ADDRESS : 292 SONORA DR SUBDIV: WOODSHIRE PH 5
 CONTRACTOR : DUSTIN BLACKWELL, INC PHONE : (919) 606-4696
 OWNER : WOODSHIRE PARTNERS LLC #223 PHONE :
 PARCEL : 01-0536-06- -0028- -63-
 APPL NUMBER: 08-50019309 CP NEW RESIDENTIAL (SFD)
 DIRECTIONS : WOODSHIRE #223
 HWY 27W TO NURSERY RD, LEMUJEL BLACK RD,
 SUB DIV ON LEFT.
 T/S: 01/28/2008 11:51 AM VBROWN ----

Job	Truss	Truss Type	Qty	Ply	Blackwell Homes / Lot 223 Woodshire	ES229887
J90483	A1	FINK	9	1	Job Reference (optional)	
Comtech, Inc., Fayetteville, NC 28309					7.060 e Jan 22 2009 MiTek Industries, Inc. Wed Mar 18 16:00:43 2009 Page 1

Re: J90483
Blackwell Homes / Lot 223 Woodshire

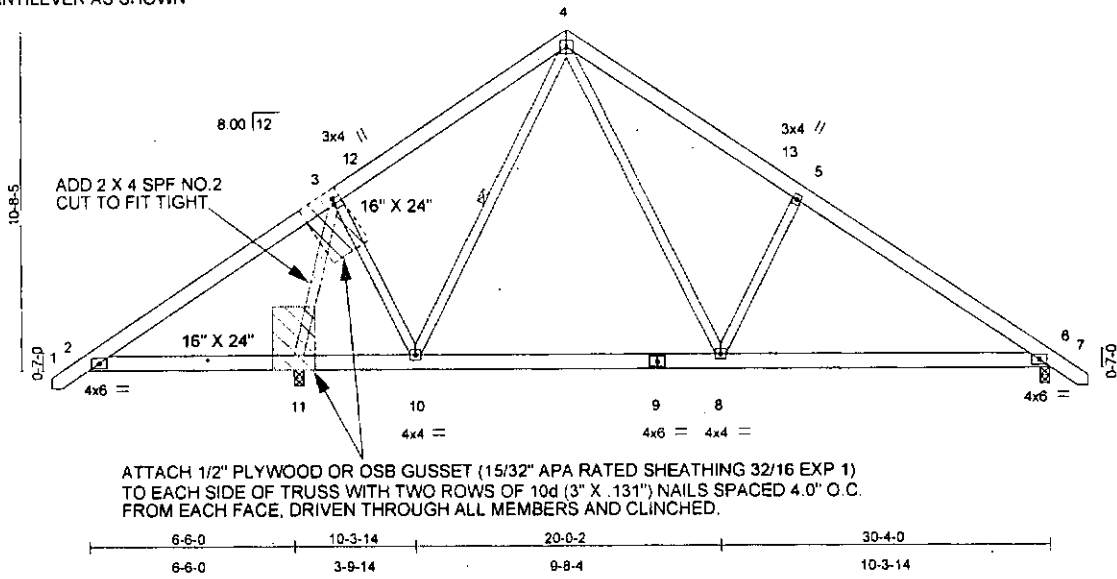
TYP/SQ	REQUESTED COMPLETED	INSP RESULT	DESCRIPTION RESULTS/COMMENTS
B101 01	2/20/09	DT	R*BLDG FOOTING / TEMP SVC POLE VRU #: 001736289
	2/20/09	AP	T-pole passed.
A814 01	2/24/09	TI	ADDRESS CONFIRMATION TIME: 17:00 VRU #: 001737279
	2/24/09	AP	292 SONORA DR LOT 223
B103 01	2/25/09	DT	R*BLDG FOUND & TEMP SVC POLE VRU #: 001737287
	2/25/09	AP	
B105 01	3/04/09	DT	R*OPEN FLOOR VRU #: 001739986
	3/04/09	AP	
R427 01	3/18/09	TI	FOUR TRADE ROUGH IN >2500 VRU #: 001744283
	<i>3-18-09</i>	<i>AA JH</i>	<i>A1 & A2 Truss are reversed need letter for repair</i>

ADD CANTILEVER AS SHOWN

ATTACH 1/2" PLYWOOD OR OSB GUSSET (15/32" APA RATED SHEATHING 32/16 EXP 1) TO EACH SIDE OF TRUSS WITH TWO ROWS OF 10d (3" X .131") NAILS SPACED 4.0" O.C. FROM EACH FACE, DRIVEN THROUGH ALL MEMBERS AND CLINCHED.
